Subject: Palo Verde Nuclear Generating Station (PVNGS)
Unit 1
Docket No. STN 50-528 (License NPF-41)
Response to NRC Questions Regarding the
Unit 1 Cycle 2 Reload Submittal
File: 87-B-056-026

NRC QUESTIONS ON PALO VERDE

UNIT 1, CYCLE 2 RELOAD AND ASSOCIATED TECH SPEC CHANGES

PALO VERDE SPENT FUEL HANDLING TOOL/CE CAST HOLDDOWN PLATE
WORST CASE LAYOUT

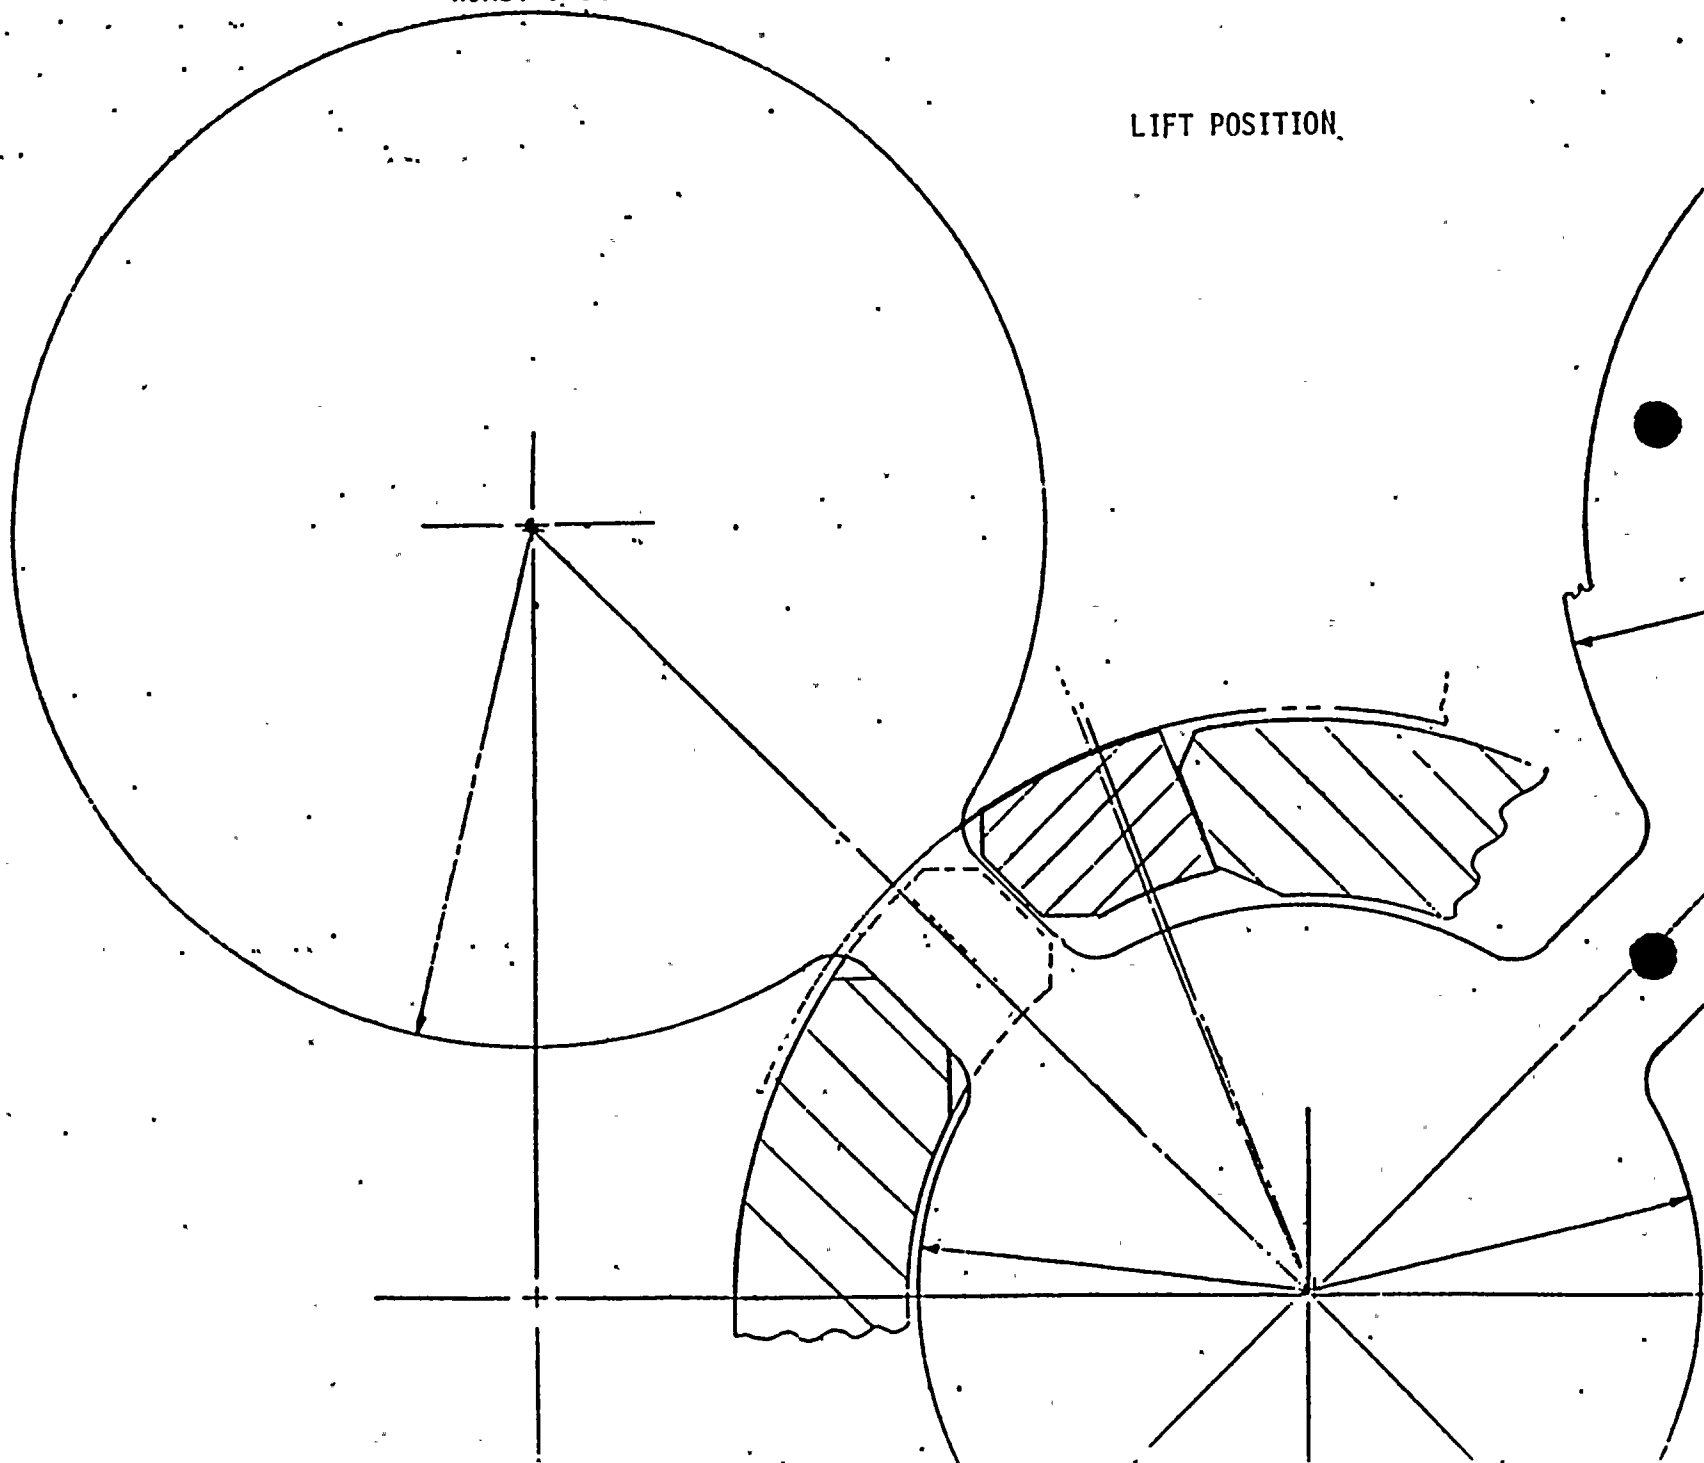
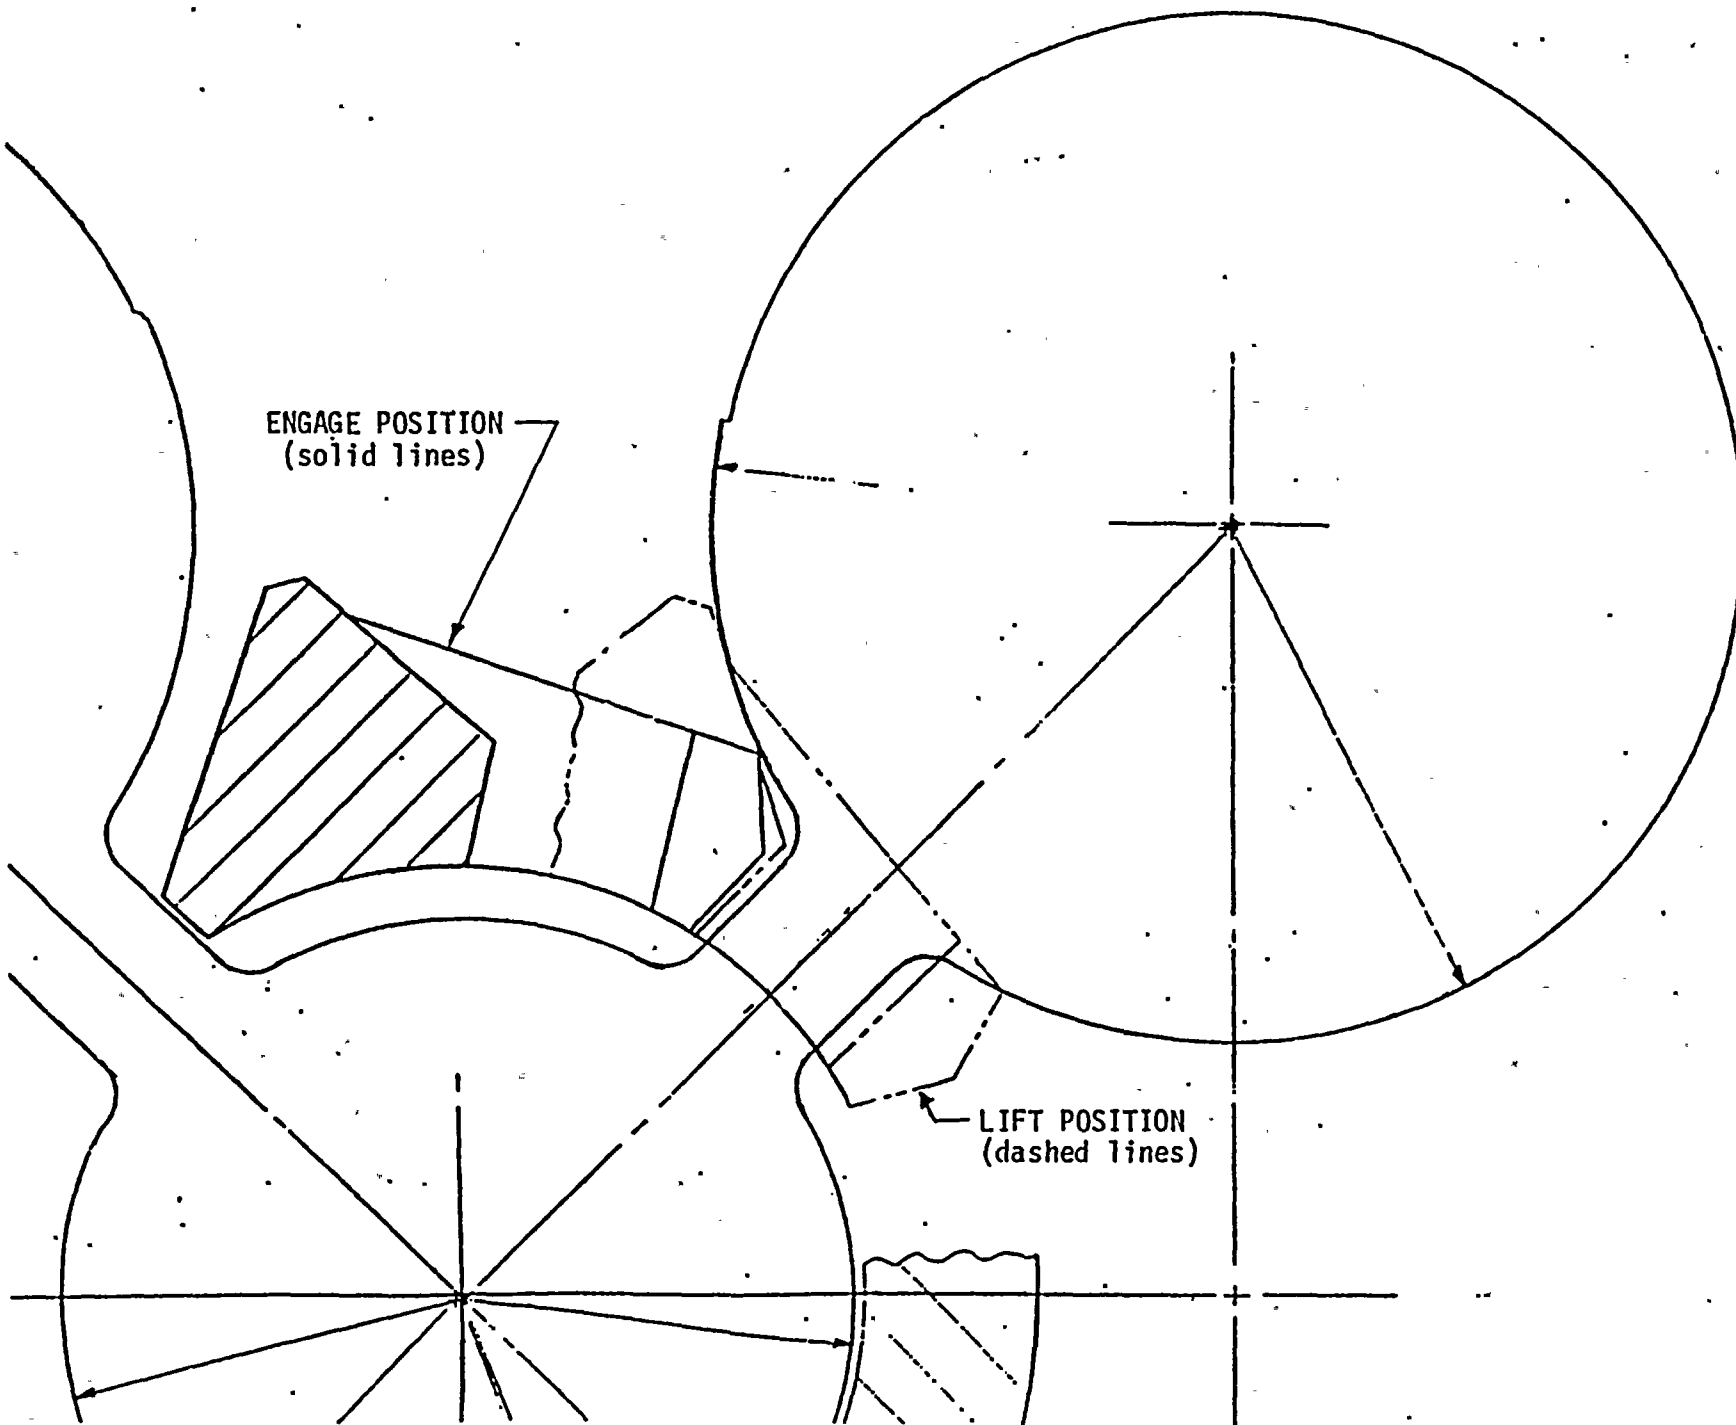
- 5.3 The result of the draftsman's layout for the three tools reviewed is included as Appendix A. As can be seen, the only tool which has a potential for interference is the Spent Fuel Handling Tool.

- 5.4 The amount of potential interference with the Spent Fuel Handling Tool based on the most adverse tolerances combined linearly is approximately 0.036 inches.

- 5.5 Utilizing the equation shown on page 508 of Ref. 3.5, a more realistic value for the potential interference becomes 0.003 inches.
- 5.6 The investment casting process used for manufacturing the C-E supplied fuel assembly hold down plates results in excellent uniformity from piece to piece. Therefore, any interference would become evident when the first bundle is handled at initial core load.

- 6.4 Based on the small magnitude of any potential interference, the strong possibility that the clearances will be larger than nominal and the adverse effect an additional clearance increase would have on the grapple engagement, it is recommended that no modifications be made to the spent fuel handling tool.
